ADDENDUM # 3

RE: **Pre-Bid Meeting Sign-In Sheet & Minutes, Question & Answer, Pay Item Addition, Additional Upgrade Items**
Contract ID: DN00659
County: Haywood
Letting Date: November 13, 2018

NCDOT HAYWOOD COUNTY I-40 EASTBOUND REST AREA
RENOVATION
SCO ID# 18-19094-01A BID SET
I-40, WAYNESVILLE, NC28786

PROJECT NUMBER: 14391.00
A201
DRAWING NUMBER

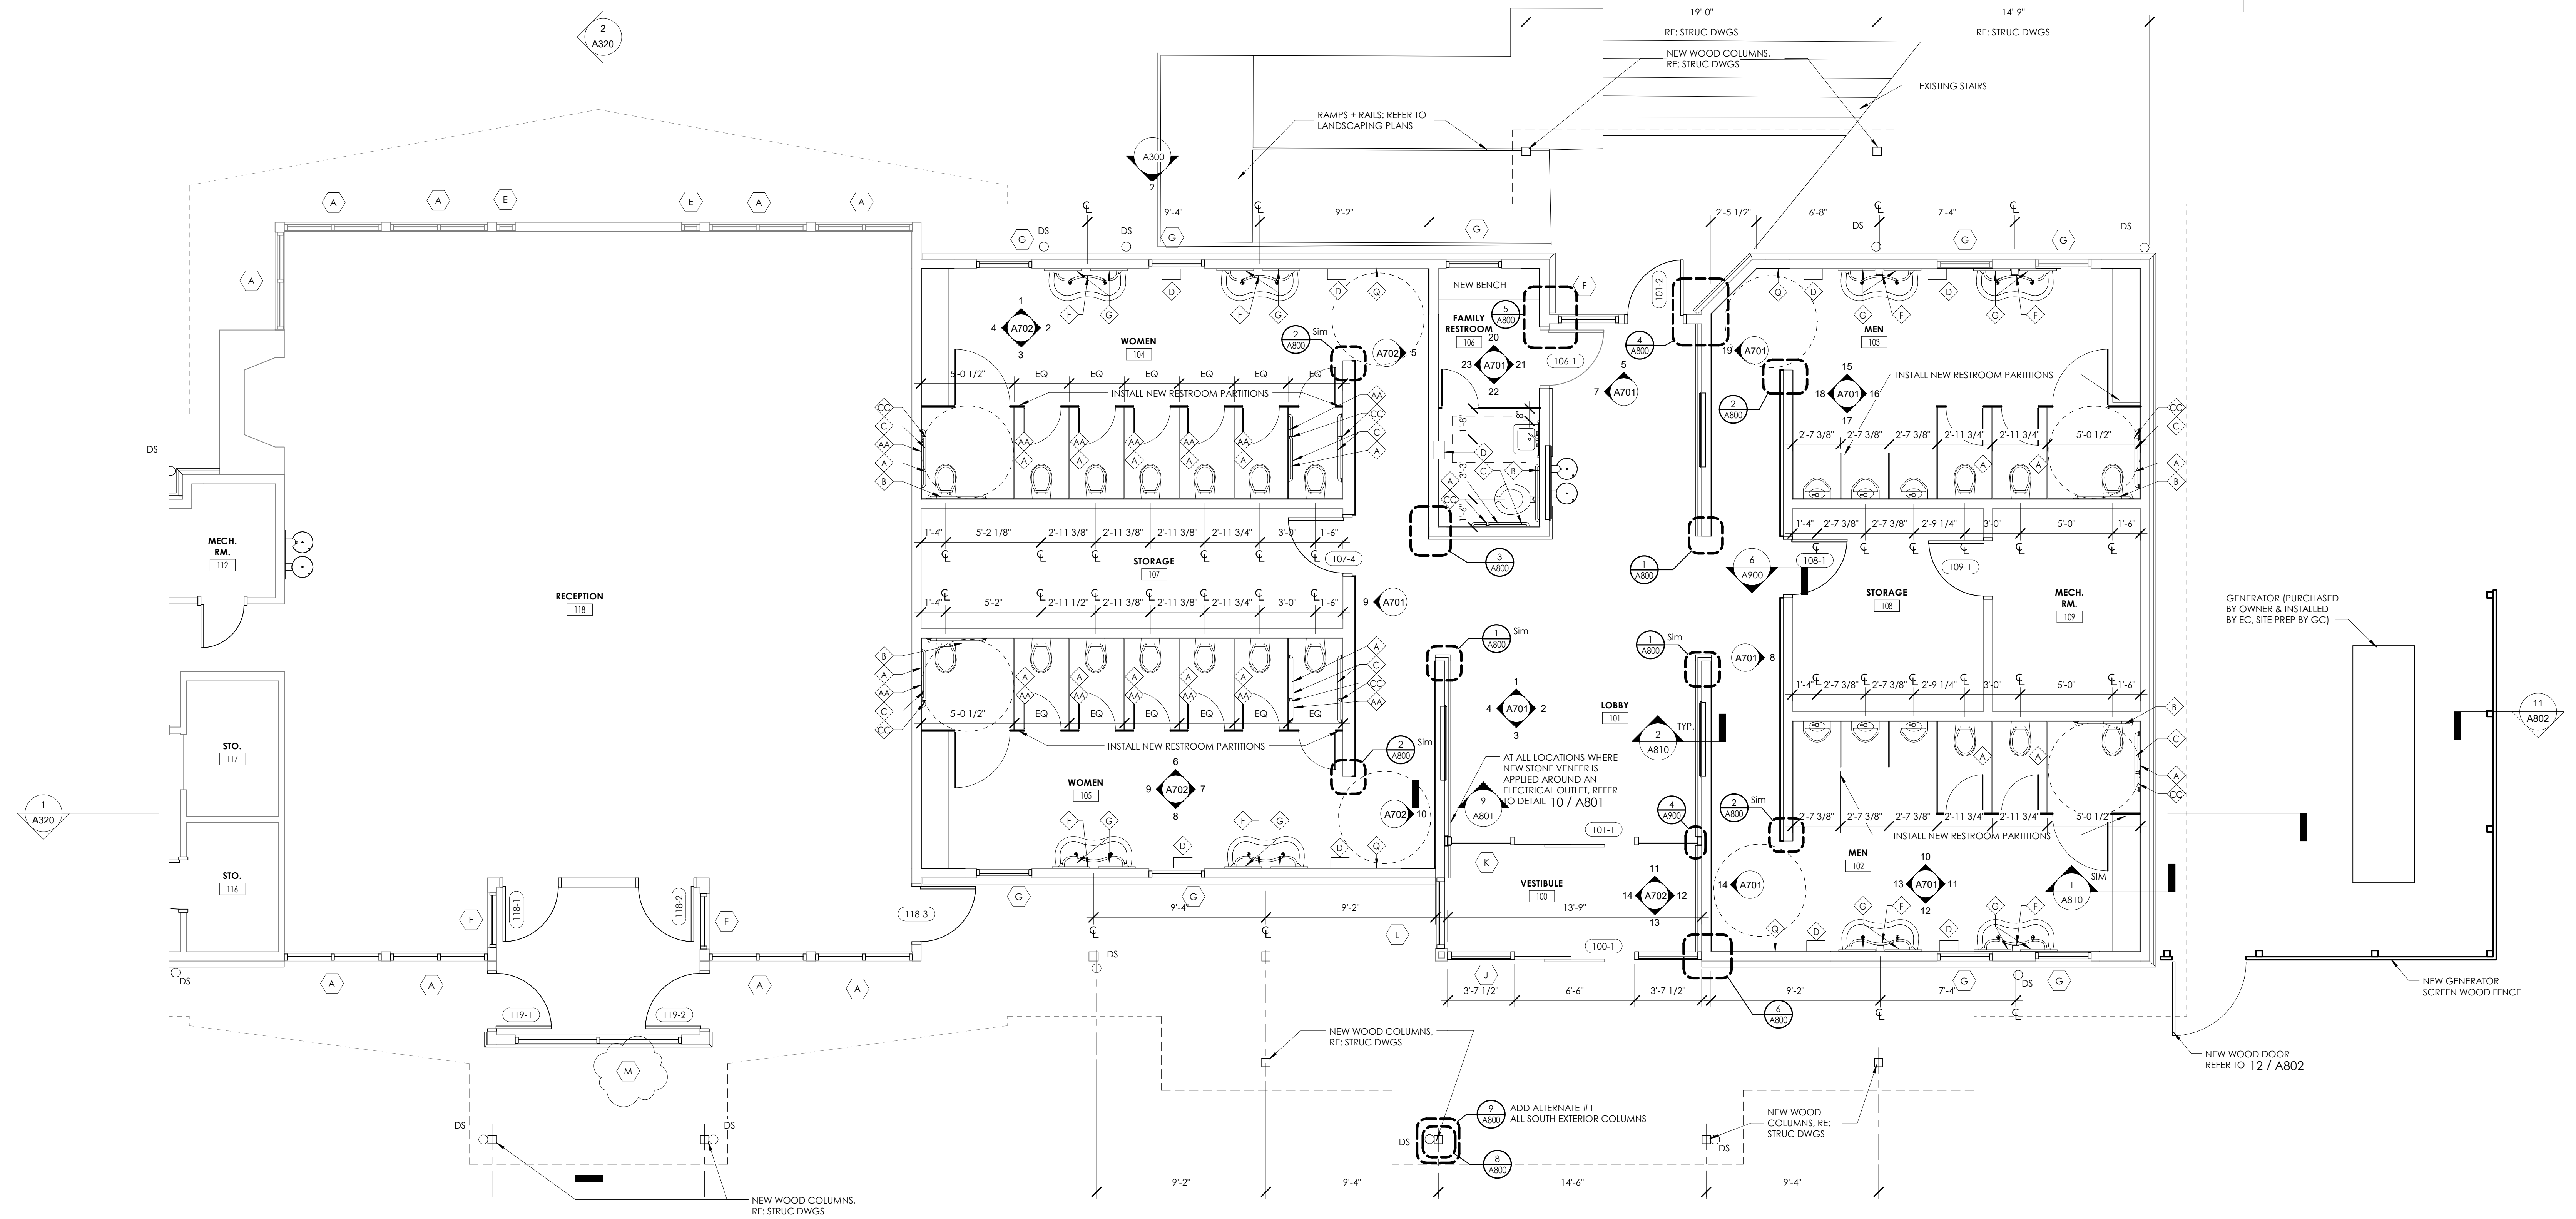
21. Question: Window type A is labeled at the vestibule outside of Reception 118. This is not the correct window type based on the width and the elevation. Please provide the correct window type.

- Answer: Refer to revised attached sheets A201 & A900 for window type.
22. Question: Please provide details that show the required outside and inside corner trim at the building exterior.

2 TYPICAL WINDOW SILL SSM @ RESTROOMS
A900 1 1/2" = 1'-0"

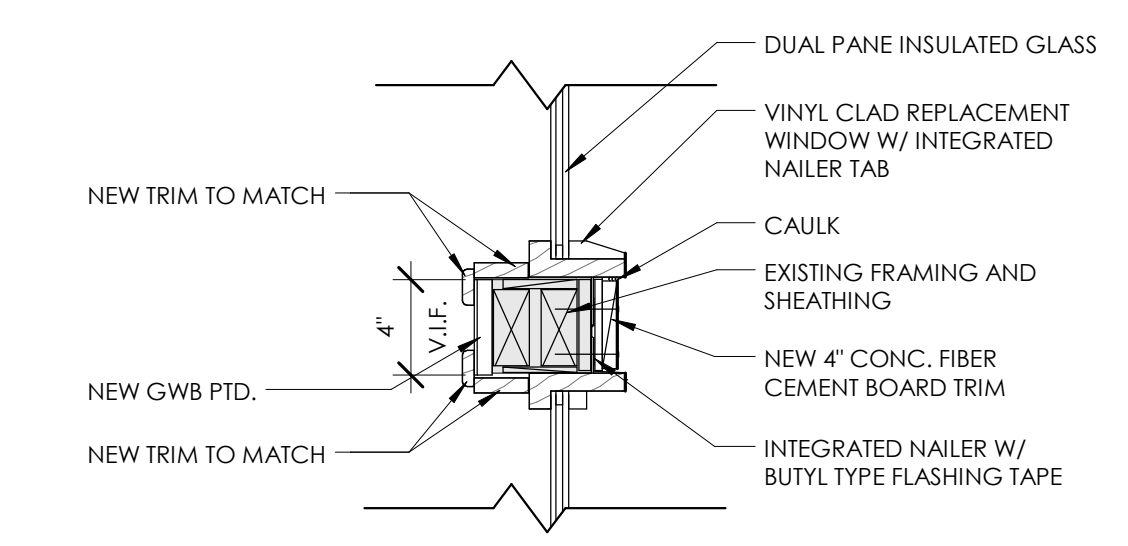
16. Question: General note 6 on sheet I200 notes “all window sills shall be SSM-1 unless otherwise noted”. Sheet A900 shows SSM window sills at the restroom (detail 2) with wood window sills at all other locations (detail 1). Please clarify, should SSM window sills be used at all windows or only at windows in restrooms?

Answer: SSM sills should be included at restroom sills only. Remainder of sills to be wood to match existing.
